# dsPIC33EPXXXGP50X, dsPIC33EPXXXMC20X/50X and PIC24EPXXXGP/MC20X

## dsPIC33EPXXXGP50X, dsPIC33EPXXXMC20X/50X and PIC24EPXXXGP/MC20X Family Silicon Errata and Data Sheet Clarification

The dsPIC33EPXXXGP50X, dsPIC33EPXXXMC20X/50X and PIC24EPXXXGP/MC20X family devices that you have received conform functionally to the current Device Data Sheet (DS70000657H), except for the anomalies described in this document.

**FIGURE 1: TIMING DIAGRAMS FOR CENTER-ALIGNED AND EDGE-ALIGNED MODES**

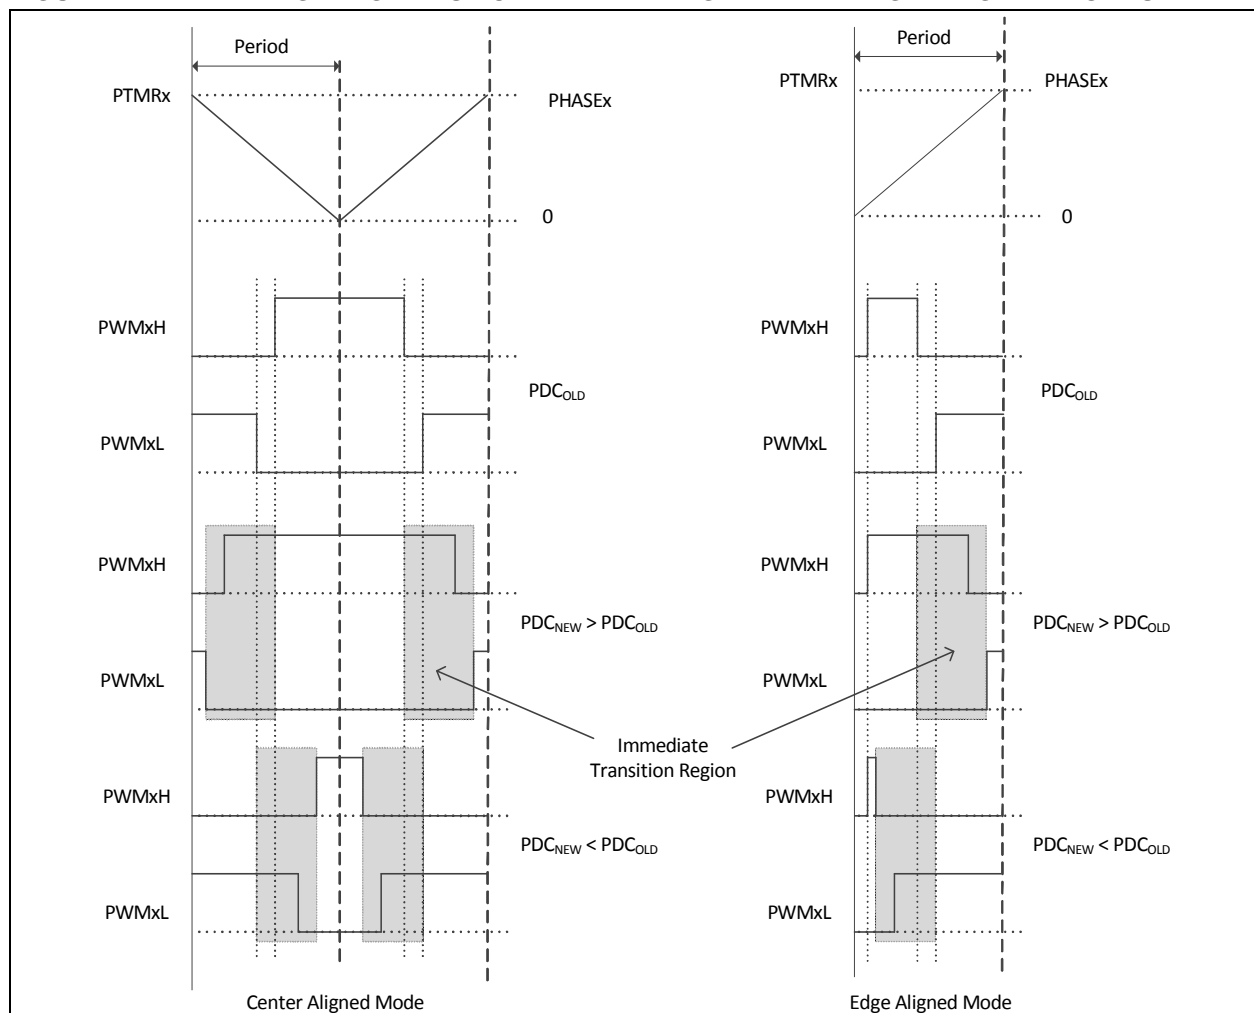
The PWM generator may not assert dead time on the edges of transitions. This has been observed when all of the following conditions are present:

- The PWM generator is configured to operate in Complementary mode with Independent Time Base (ITB) or master time base;
- Immediate update is enabled; and
- The value in the PDC register is updated in such a manner that the PWMxH and PWMxL outputs make an immediate transition.

The current duty cycle, PDC<sub>OLD</sub>, newly calculated duty cycle, PDC<sub>NEW</sub>, and the point at which a write to the Duty Cycle register occurs within the PWM

time base, will determine if the PWMxH and PWMxL outputs make an immediate transition. PWMxH and PWMxL outputs make an immediate transition if the Duty Cycle register is written with a new value, PDC<sub>NEW</sub>, at a point of time when the PWM time base is counting a value that is between PDC<sub>NEW</sub> and PDC<sub>OLD</sub>. Additionally, writing to the Duty Cycle register, close to the instant of time where dead time is being applied, may result in a reduced dead time effective on the PWMxH and PWMxL transition edges.

In [Figure 1](#), if the duty cycle write occurred in the shaded box, then PWMxH and PWMxL will make an immediate transition without dead time.

None.

However, in most applications the duty cycle update timing can be controlled using the TRIGx trigger, or Special Event Trigger, such that the above mentioned conditions are avoided altogether.

**FIGURE 2: PWM TIMING DIAGRAM**

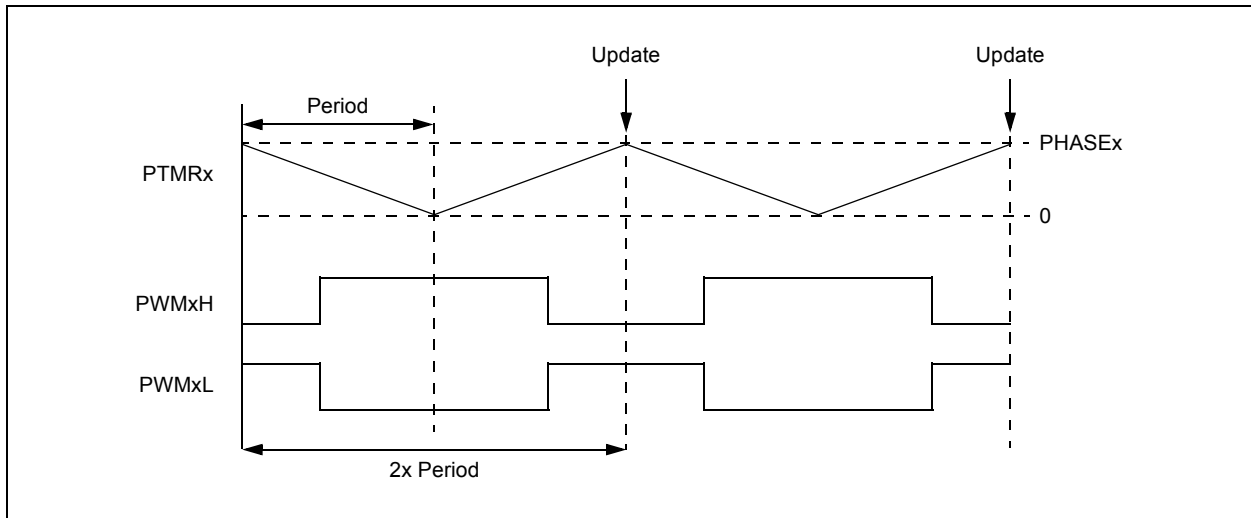
In Center-Aligned mode, updates to active MDC/PDCx/ALTDTRx/PHASEx registers occur only once every two PWM periods; that is, when the PWM timer matches the PHASEx register. In other words, the double update feature is not available. Figure 2 illustrates this relationship.

**FIGURE 3: CORRECT AND INCORRECT POSITION COUNT CAPTURES**

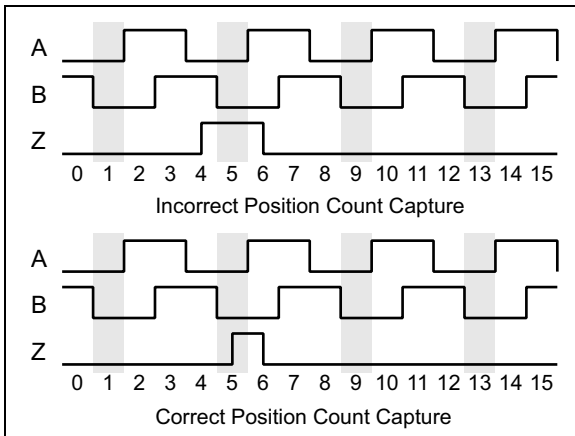
When index count position capture is being used (QEIXOC.QCAPEN = 1), the position count may be one more or one less than the correct value, depending on the direction of the count.

This is only observed when the leading edge of the index pulse occurs prior to the leading edge of the index match event. When the index pulse starts after the leading edge of the index match event, the position count is captured correctly.

Figure 3 shows how this occurs. In these cases, Encoder Signals A, B and (index) Z are shown, with the module being configured for index match when A and B are '0'. The effects of a correct and incorrect capture are shown side by side (shaded area indicates the index match event); the position count is shown along the bottom.

For encoder signals with timing that ensures the index pulse always starts prior to the start of the index match event (i.e., encoders with a non-gated index pulse), measure the direction of the encoder motion. If the encoder is counting up, add one to the captured position count; if the encoder is counting down, subtract one from the captured position count.

For encoder signals where the index pulse leading edge approximately coincides with the start of the index match event (i.e., encoders with a gated index pulse), a small delay can be added to the index pulse, for instance, by using a simple R-C filter.

FIGURE 4: PWM GENERATOR TIMING DIAGRAM

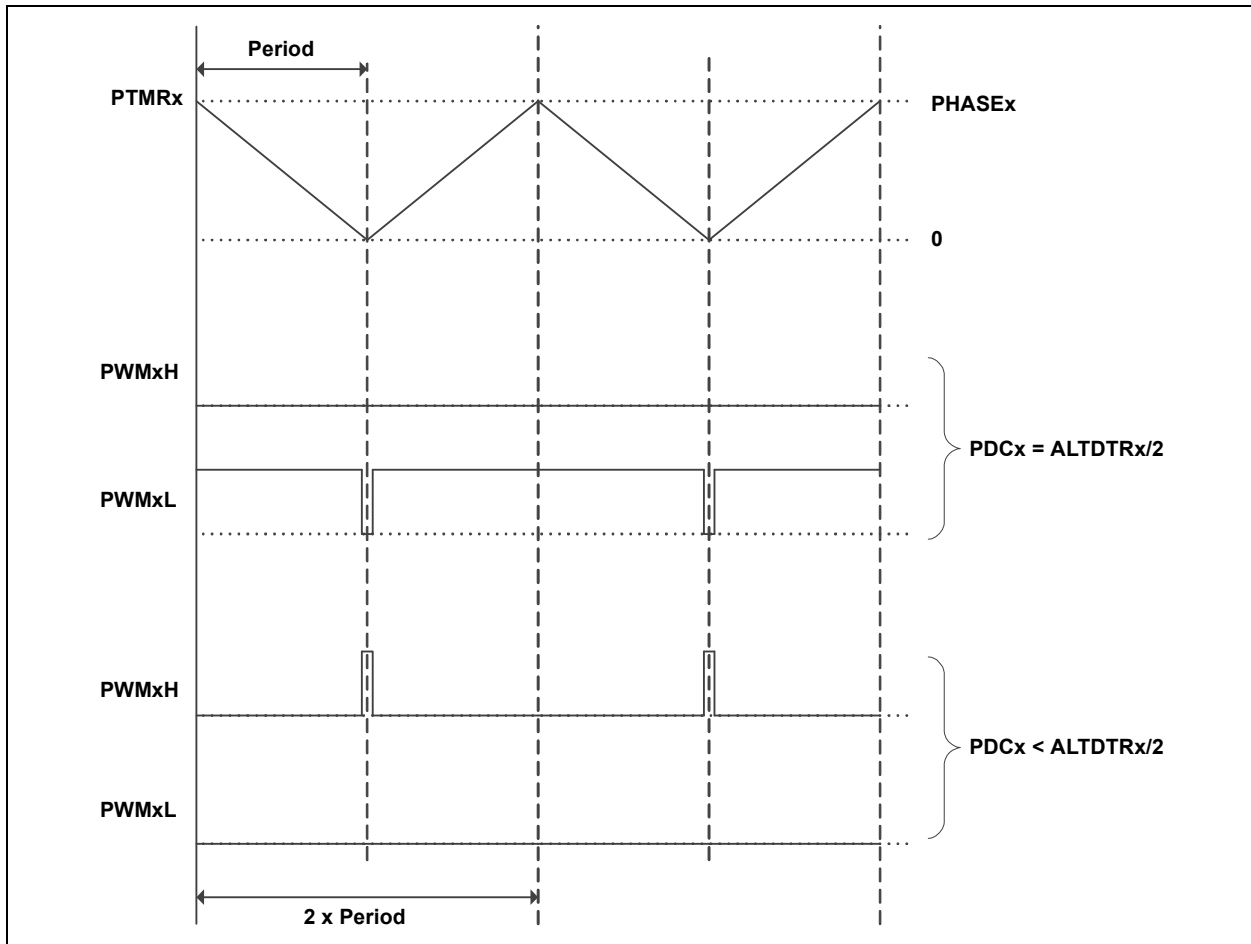
In Center-Aligned Complementary mode with Independent Time Base, if the value in the PDCx register is less than one-half the value in the ALTDTRx register, the PWM generator will force the PWMxL to low, and on the PWMxH, generate pulses of width less than twice the dead time, as shown in Figure 4.

**FIGURE 5: ILLUSTRATION OF 1 T<sub>osc</sub> GLITCH WHEN PWM OVERRIDE IS TURNED OFF**

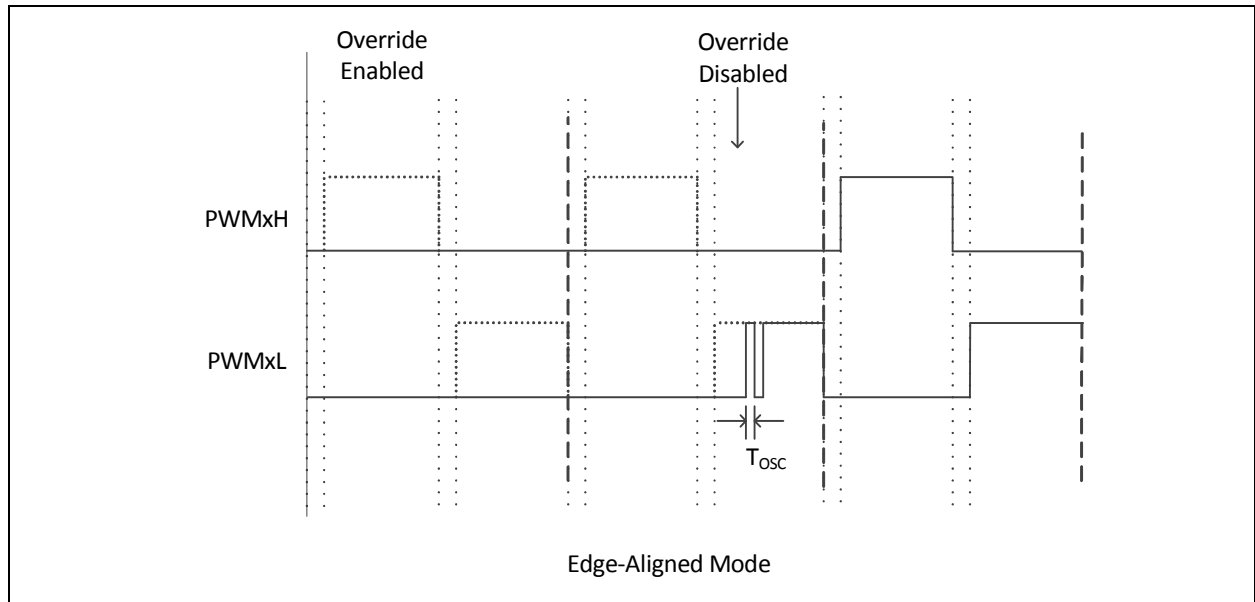
In Complementary mode after the PWMx module is enabled (PTEN = 1), if the PWM override is turned off, a 1 T<sub>osc</sub> glitch will be present on the rising edge of either PWMxH or PWMxL, whichever occurs first, as shown in Figure 5. The glitch will be present on PWMxH/PWMxL every time the override state is changed from enabled to disabled. The width of this glitch is equal to 1 T<sub>osc</sub> when PCLKDIV<2:0> = 000; increasing the PWM input clock prescaler setting will increase the width of the glitch accordingly.

**FIGURE 6:**

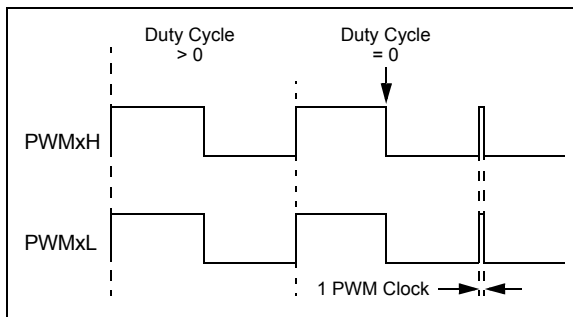
In certain output modes, the PWMx module produces a pulse glitch of one PWM clock in width (Figure 6). This has been observed only when all of the following are true:

- Either Redundant or Push-Pull Output mode is selected (IOCONx<11:10> = 10 or 01);
- Immediate Update is disabled (PWMCONx<0> = 0); and
- The value of the current Duty Cycle register (either the PDCx or MDC register, as determined by PWMCONx<8>) is updated to zero from any non-zero value.

The pulse glitch has been observed to occur at the beginning of the following PWM boundary period.

**FIGURE 7:**

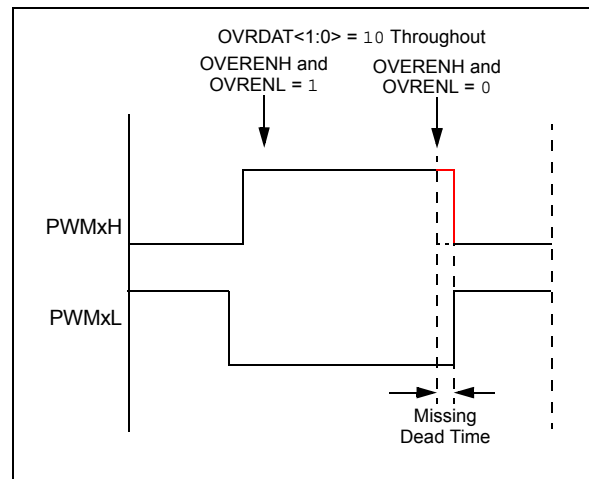
- Output override synchronization is configured to occur on the CPU clock boundary (IOCONx<0> = 0);
- Both PWMxH and PWMxL overrides are enabled prior to the event (OVRENH and OVRENL are both '1'), and
- Both overrides are disabled (OVRENH and OVRENL are both '0') at the instant the dead time should be asserted (Figure 7).

This has been observed in both Center-Aligned and Edge-Aligned modes.

**FIGURE 8:**

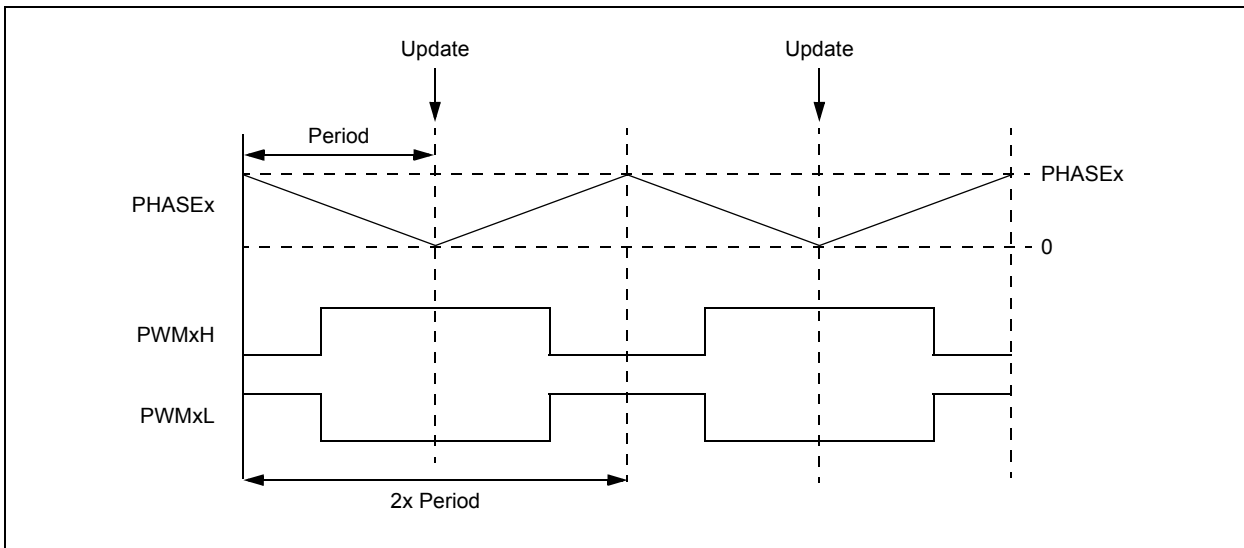
In Center-Aligned Complementary mode with Independent Time Base, updates to the PHASEx register take effect in the middle of a center-aligned PWM cycle, as shown in Figure 8. This occurs only when the Immediate Update feature is disabled (IUE = 0). If Immediate Update is enabled (IUE = 1), the PHASEx register updates will take effect immediately.

**FIGURE 9: SIMPLIFIED BEHAVIOR**

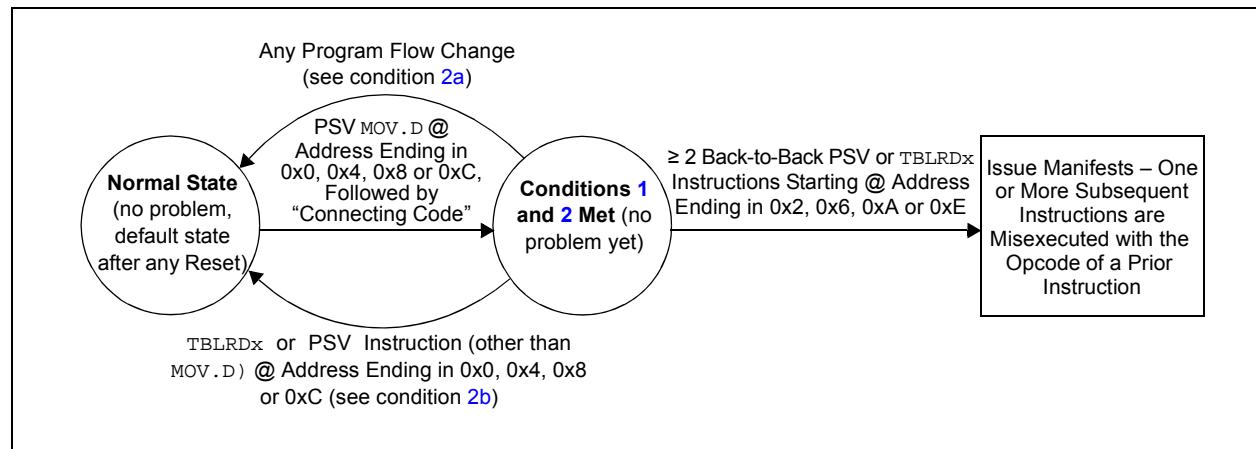
3.	≥ 2 back-to-back PSV or TBLRDx instructions are executed (following the code of condition 2), where the first of the back-to-back instructions is located at an address ending in 0x2, 0x6, 0xA or 0xE.

Figure 9 provides an example of the effective behavior.

1. All instances of PSV `MOV.D` can be replaced with two PSV `MOV` instructions instead. Non-PSV `MOV.D` instructions acting on RAM/SFRs do not need to be modified; or
2. If not already present, a program flow change instruction (such as `BRA $+2`) can be inserted above back-to-back data Flash read sequences; or
3. Back-to-back data Flash read instruction sequences can be broken up by inserting a non-Flash read instruction (such as a `NOB`) in between the Flash read instructions; or
4. The alignment of the code can be shifted to avoid the required opcode location addresses.

C code built with MPLAB® XC16 Compiler, Version 1.32, or later, implements the work around by default. However, if the application uses Assembly language routines, these should be manually modified to implement the work around. Additionally, if precompiled libraries are used, these should be built with XC16 Version 1.32 or later. For additional information, please visit: [www.microchip.com/erratum\\_psrds\\_psrds](http://www.microchip.com/erratum_psrds_psrds).

**FIGURE 32-10: TYPICAL LPRC FREQUENCY @ VDD = 3.3V**

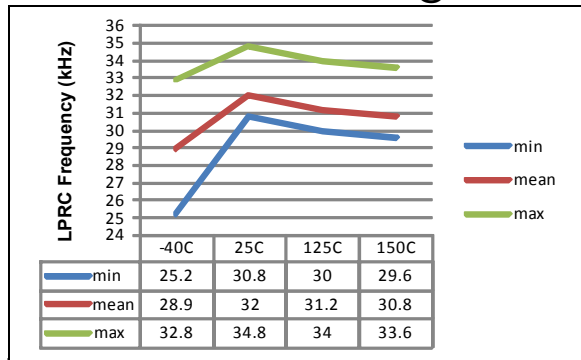
The typical LPRC frequency plot over temperature at VDD = 3.3V has been corrected, as shown in Figure 32-10 below.

**FIGURE 25-1: OP AMP/COMPARATOR x MODULE BLOCK DIAGRAM (MODULES 1, 2 AND 3)**

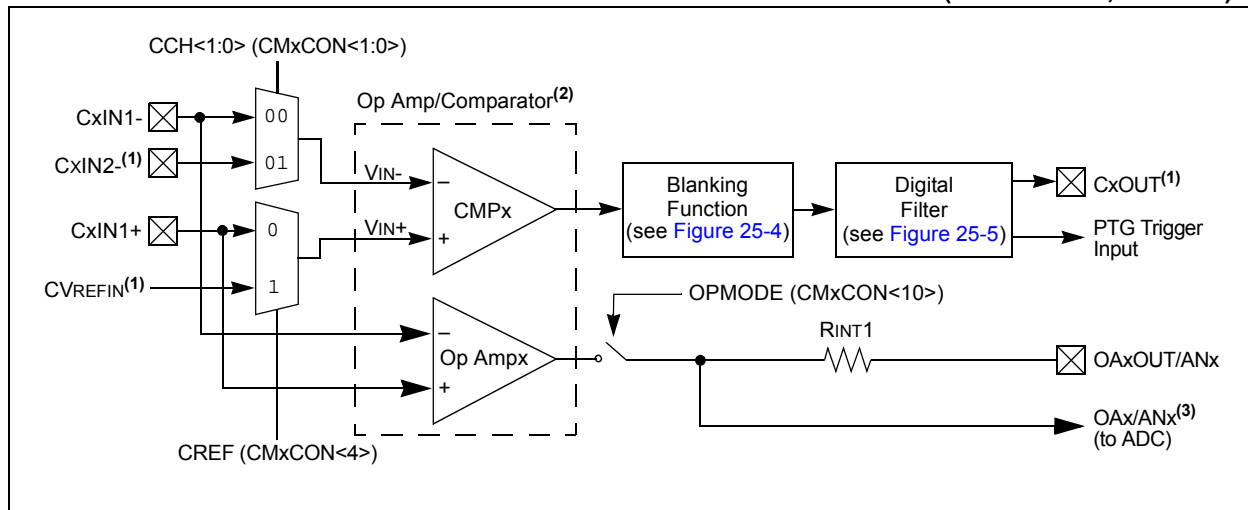
Figure 25-1 (shown below) is corrected to show that the op amp in these modules obtains its inverting and non-inverting inputs directly from the CxIN1-/1+ pins. The operation of the actual module is unchanged. (Footnotes in the original are unchanged, but are removed here for clarity.)
